## Product Change Notification

1. ECR #: 172748  
Notification #: 426

- IPBD - Power Cable Connector
- PMSD - .165 SOCKET DISCREET CABLE ASSEMBLY
- PMSDT - .165 SOCKET DISCREET CABLE ASSEMBLY

Samtec is revising the geometry and material for IPBD-D to improve latch functionality

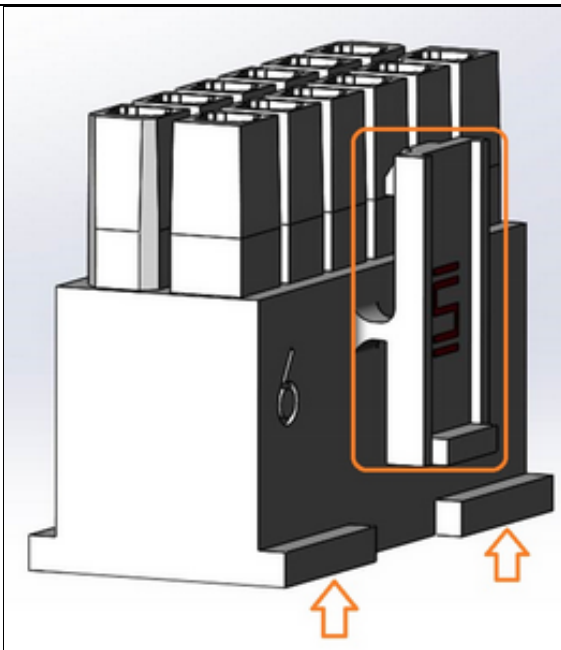
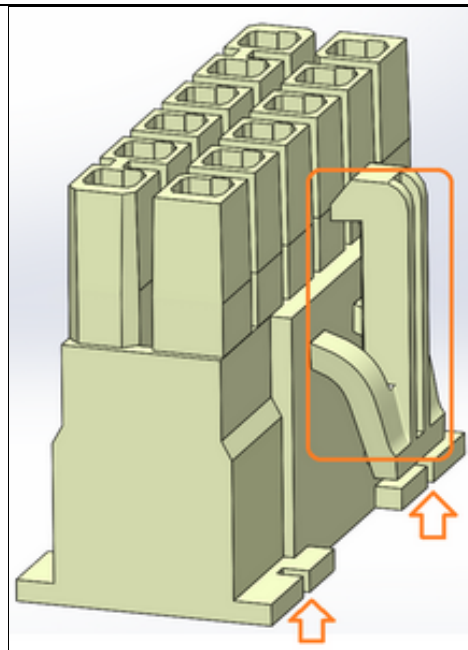
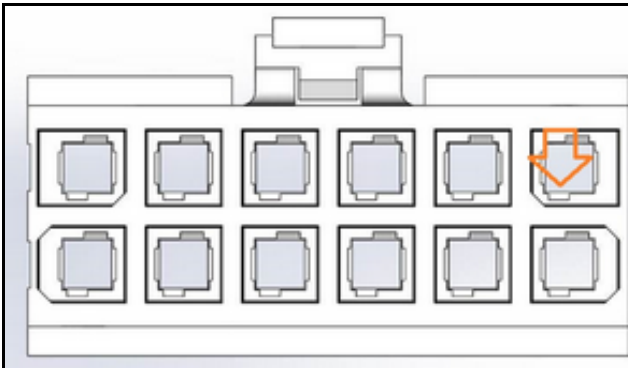
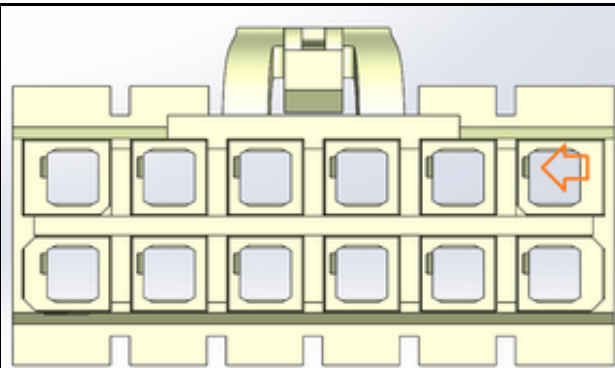
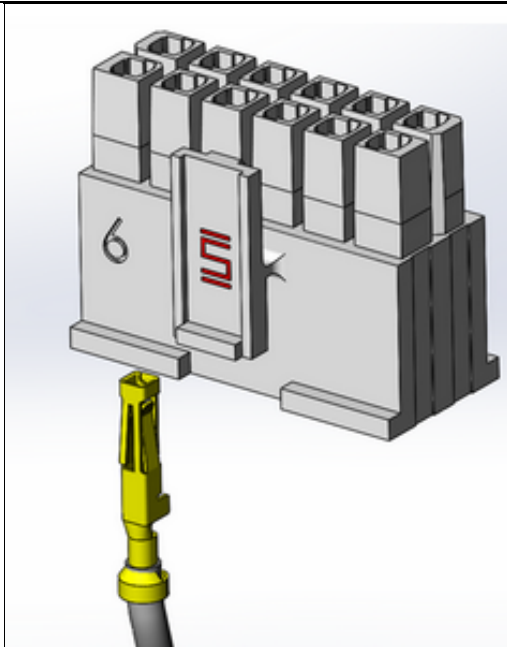
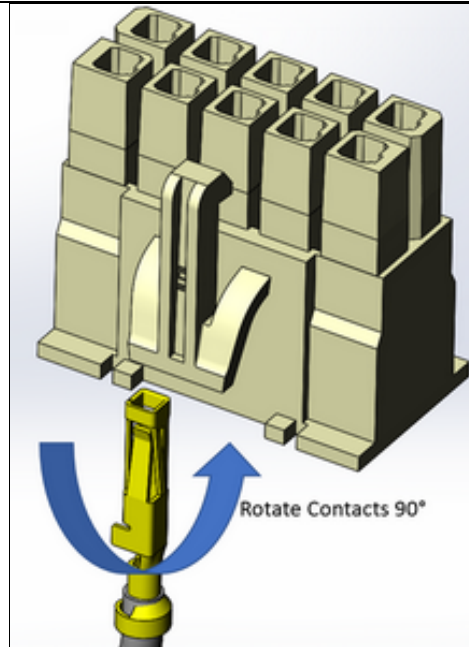
Visual difference in latch geometry.

- Form - Latch geometry change
- Form - Increased void coring between towers
- Form - Notches added on base on connector
- Form - Material is switching from PBT to nylon. Bodies are slightly different in color. New bodies are

off-white/cream colored. Previous revision bodies are colored white

- Fit - Customers who purchase IPBD bodies and perform crimp and poke assembly will need to rotate the crimped contact 90 degrees for proper insertion.
- Function - The UL-94 flammability rating was changed from V0 to V2. This is consistent with other Samtec series within this product family, including IPD1 and MMSD..
